From: HANSON, Jerud <jeh@nei.org>
Sent: Monday, March 12, 2018 1:54 PM
To: Benner, Eric; Govan, Tekia
Cc: REMER, Jason; HANSON, Jerud
Subject: [External_Sender] Industry Feedback for March 14th RIS Public Meeting
Attachments: NEI Members Comment Worksheet - March 2018 RIS Version 3-12-2018.xlsx; ML18051A084 - RIS 2017-XX - With Line Numbers.pdf; RIS Operating Experience Section Suggested Rewrite.pdf; Table 2 Suggested Revision.pdf

INDUSTRY COMMENTS TO MARCH 2018 DRAFT RIS 17-XX SUPPLEMENT-1 TO RIS 2002-22						
LINE NO.	PAGE NO.	PRIORITY	INDUSTRY COMMENT	RECOMMENDED CHANGE	ADDITIONAL COMMENTS	ACTION TAKEN
61	2 of 5	1	Stating that DI&C upgrades associated with the RPS/ESFAS is out-of-scope for the RIS Supplement has the potential to communicate that SSCs supporting or actuated by the RPS/ESFAS logic would also be off the table. This significantly limits the SSCs available to be upgraded under this RIS Supplement.	Suggest replacing 2 sentences starting on line 61: "This RIS Supplement is not directed toward large-scale analog-to-digital upgrades of the reactor trip and engineered safety features actuation logic, since application of the guidance in this RIS Supplement to such change

Figure 1 – EXAMPLE ENGINEERING EVALUATION PROCESS

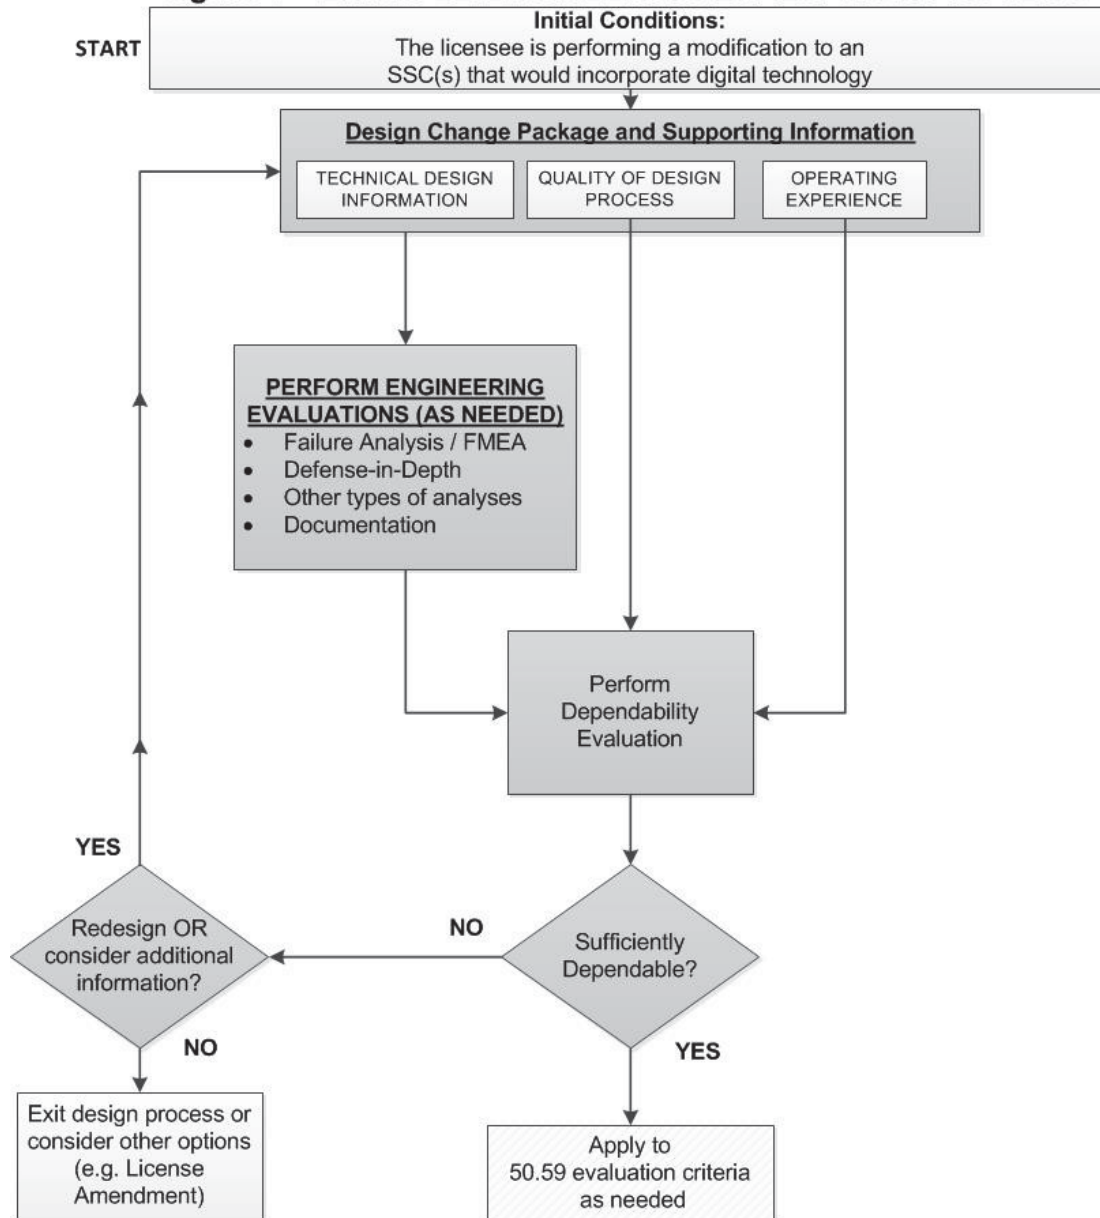
INDUSTRY COMMENTS TO MARCH 2018 DRAFT RIS 17-XX SUPPLEMENT-1 TO RIS 2002-22						
LINE NO.	PAGE NO.	PRIORITY	INDUSTRY COMMENT	RECOMMENDED CHANGE	ADDITIONAL COMMENTS	ACTION TAKEN
807	14 of 17	1	Consider deleting Figure 1. This figure leads a licensee to believe that only a Dependability Evaluation is needed. Licensees would prefer to have the RIS provide guidance strictly on Qualitative Assessments for determining equipment/SSC reliability, and then using the Qualitative Assessment to support arguments made in the 50.59 Evaluation.			
810	15 of 17	1	Table 2 - See industry version of Table 2.			
NA	NA	1	This document provides a lot of guidance on I&C design, in particular, for non-safety related systems. In some cases, the requirements go beyond what is required by the operational quality assurance program used by licensees, and design and licensing bases requirements for non-safety related systems. The RIS should focus on the licensing aspects, not the design aspects of digital upgrades.	Remove design requirements from the RIS. Inclusion of design attributes is useful, and should remain.	Licensees know how to design - they have very detailed and proceduralized guidance along with a quality assurance program. NRC and licensees have not been aligned on adequate documentation of design considerations. The new RIS is supposed to provide licensees with acceptable methods for documenting qualitative assessments for relaying their design thought process in a way that an inspector can understand pertinent design considerations.
